DUKE POWER COMPANY

Re: McGuire Nuclear Station
Units 1 and 2
Docket Nos. 50-369, 50-370

Due to floor elevation changes in the vicinity of the McGuire containment sump, it was necessary to modify the sump screen design presented in Figures 16 and 24 of Alden Research Laboratory Report No. 29-78/M208JF which was transmitted to you on June 30, 1978 as part of Amendment 53 to the McGuire license application. Attachments 1 and 2 are marked up figures from this report showing the changes. We have reviewed these changes and have concluded that they would not adversely affect sump performance. Attachment 3 is a letter from Alden Research Laboratory to Duke Power Company which supports this conclusion.

FIGURE 16 SECTIONS A-A AND B-B SHOWING THE REVISED DESIGN OF CONTAINMENT SUMP

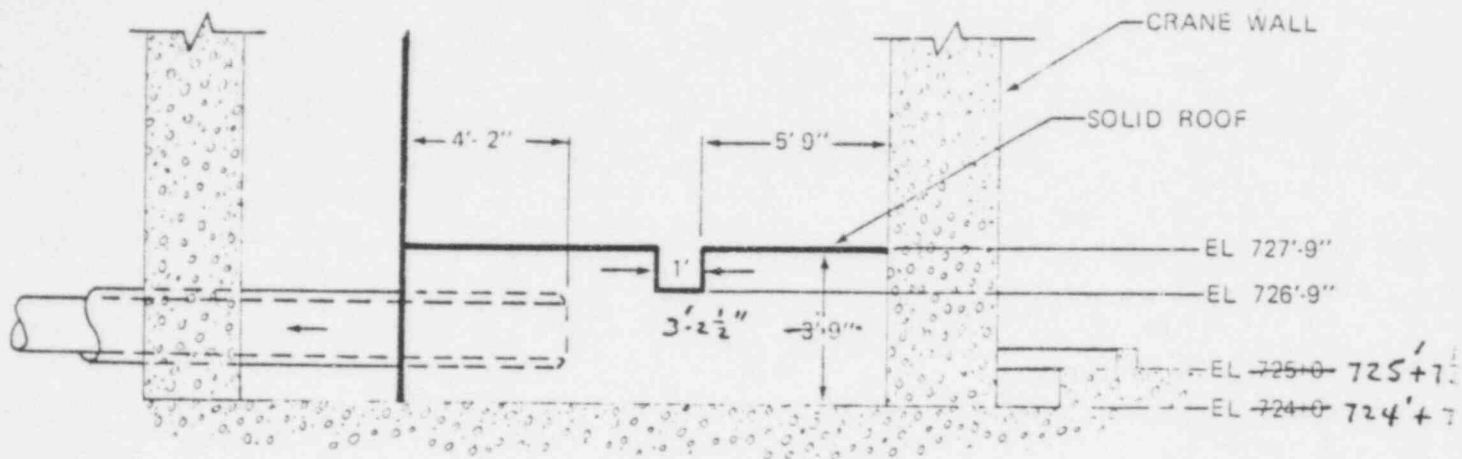
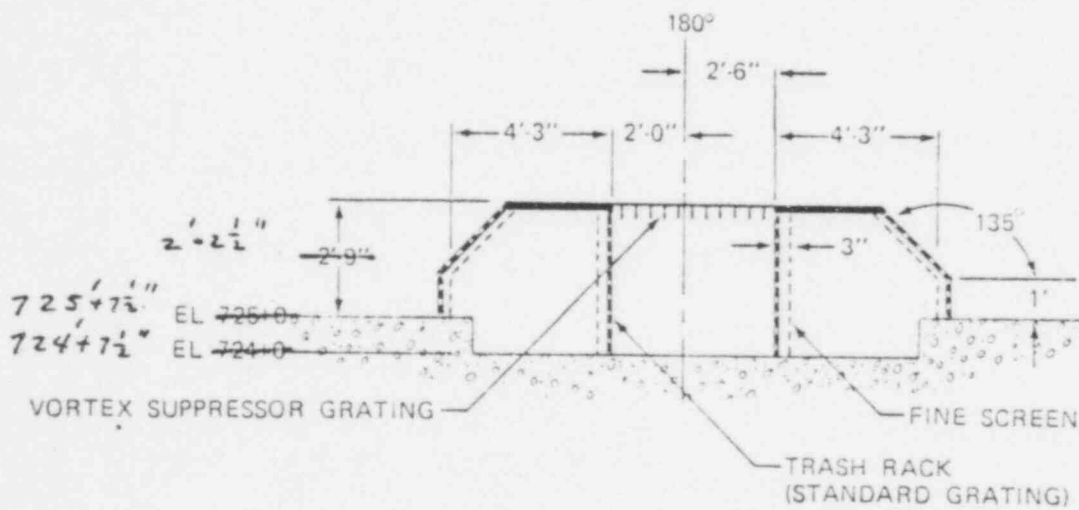
The reduction of screen area of 164 square feet to 135 square feet will increase the approach velocities to the screen by about 20%, from 0.198 to 0.24 ft/sec. As the submergence of the pipe (pipe centerline still at EL 726) and the overall sump orientation are not changed, no major changes in the flow pattern to the sump and to the pipe are expected with the new changes in screen area. Hence, the position of the vortices would be more or less the same as previously observed in the model tests. Earlier tests have showed that even with prototype velocities in the model suction pipes, the most severe vortices were of weak dye core type, and these were disrupted by the vortex suppressor gratings provided in the recommended design (Figures 15, 16, and 24 of ARL Report No. 29-78/M208JF).

As no major changes in the flow pattern in the sump vicinity and at the pipe entrance are likely with the proposed screen area changes, no practical increases in the swirl or entrance losses are anticipated. However, due to the increase in approach velocity, the screen losses would be somewhat increased. The expected screen losses with the proposed screen area reduction would be about 0.6 inches of water, which is small compared to the total intake losses.

Based on the above factors, the proposed changes in the screen area will not contribute to any adverse changes in flow conditions in terms of vortexing, swirl, or inlet losses in the sump behavior relative to those predicted by ARL hydraulic model tests, reported in ARL Report No. 29-78/M208JF.
